NOAA FORM 76-35A U.S. DEPARTMENT OF COMMERCE NATIONAL OCEANIC AND ATMOSPHERIC ADMINISTRATION NATIONAL OCEAN SERVICE DESCRIPTIVE REPORT
1719	Type of Survey Hydrographic Survey Field No. N/A Registry No. H11719
I	LOCALITY State Alaska General Locality Akutan Pass Sublocality NE of Sedanka Island 2007 CHIEF OF PARTY DEAN MOYLES
	LIBRARY & ARCHIVES

U.S. D NATIONAL OCEANIC AND ATM	EPARTMENT OF COMME OSPHERIC ADMINISTRA	
	HYDROGRAPHIC TITLE SHEET		H11719
	- The Hydrographic Sheet should be accompanions of the optimized by the op	ed by this form, fille	d in FIELD No: N/A
State <u>Alaska</u>			
General Locality	Akutan Pass		
Sub-Locality	NE of Sedanka Island		
Scale <u>1:10,00</u>	00	Date of Survey	June 16 to July 28, 2007
Instructions date	d <u>6/15/2006</u>	Project No.	OPR-Q191-KR-07
Vessel R/V D	avidson (1066485) , R/V R2 (623241), R/V	D2 (647782)	
Chief of party Surveyed by	DEAN MOYLES ORTHMANN, REYNOLDS, GILL, MO		
Soundings by	RESON 8101 (R2 & D2 - HULL MOUNT		
SAR by		mpilation by A	mie Raymond
Soundings compi			
The purpose of nautical charts	times are UTC. UTM Zone 3N f this survey is to provide contemporary su a. All separates are filed with the hydrograp ng office processing. P

Figure 2 Profile of 1H05-TIE01

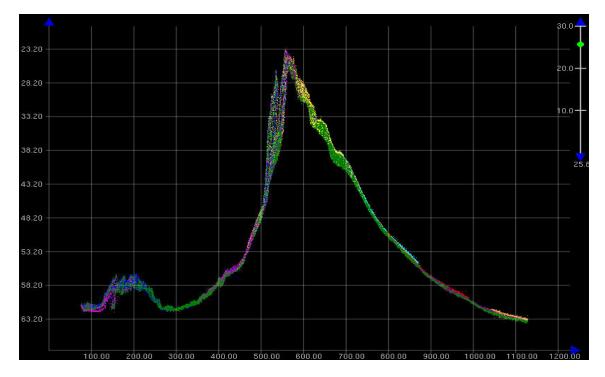
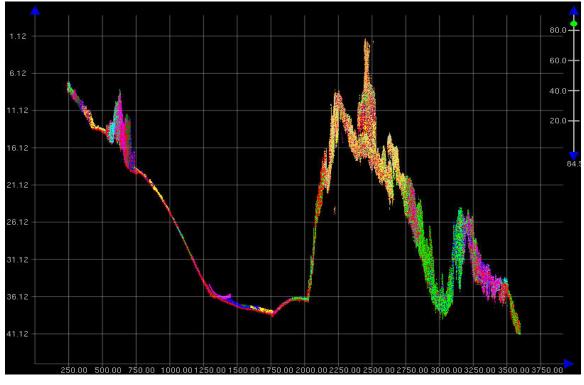
The majority of beams that fall below the 95 percent confidence level are located in areas having extremely steep slopes and/or rocks². Figures 2 and 3 below provide examples.

² Concur.

Figure 4 H11719 Uncertainty DTM

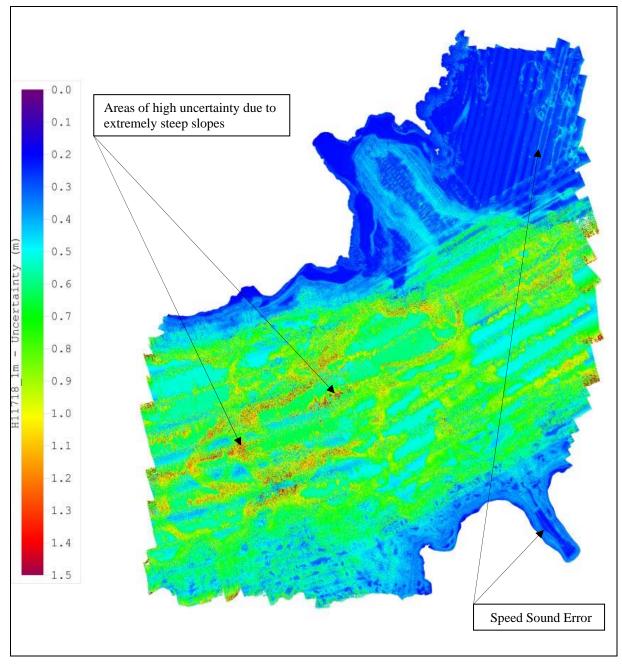
The majority of H11719 had an uncertainty of about 0.20 to 0.50 meters, except for the deep water areas having extremely steep slopes or deemed to be rocky, where values ranged from 0.60 to 1.0 meters. No uncertainty values were greater than the IHO level Order $1.^3$

³ Concur.

Figure 5 H11719 Survey Junctions

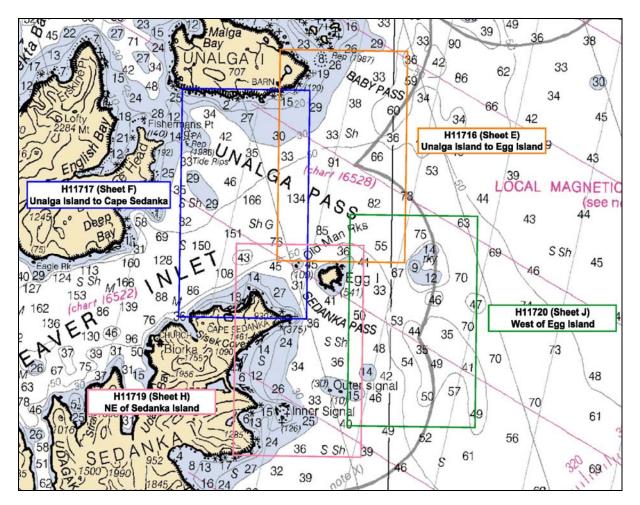
H11719 (Sheet H) junctions with⁴:

The surveys are in agreement along their common borders. The agreement was noted in the field using the CARIS CUBE surfaces during subset cleaning. The conformity is also apparent in the final combined BASE surfaces.⁵

⁴ A common junction was created between H11719 and surveys H11716 ,H11717 and H11720.

⁵ Concur.

Figure 6 H11719 Electronic Chart Comparison (US3AK61M)

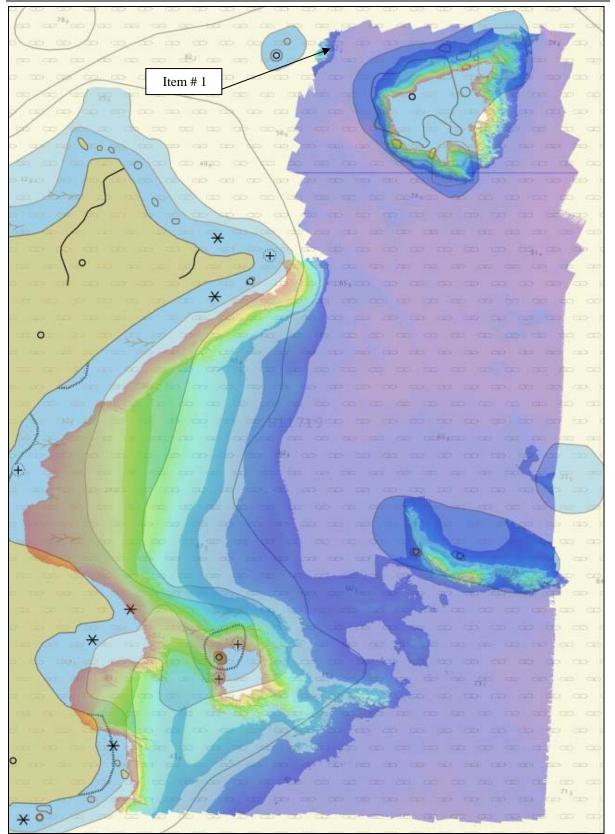
Item # 1: Hydrographic survey H11719 revealed a depth of 63 fathoms in the vicinity of a 82.2 fathom sounding on chart US3AK61M located at 53°52'13" N, 166°04'22" W. This area was surveyed with 100% multibeam coverage. The shoaling is centered in the area depicted below.

¹⁴ Concur generally with sounding comparison unless otherwise noted. Chart soundings per HCell.
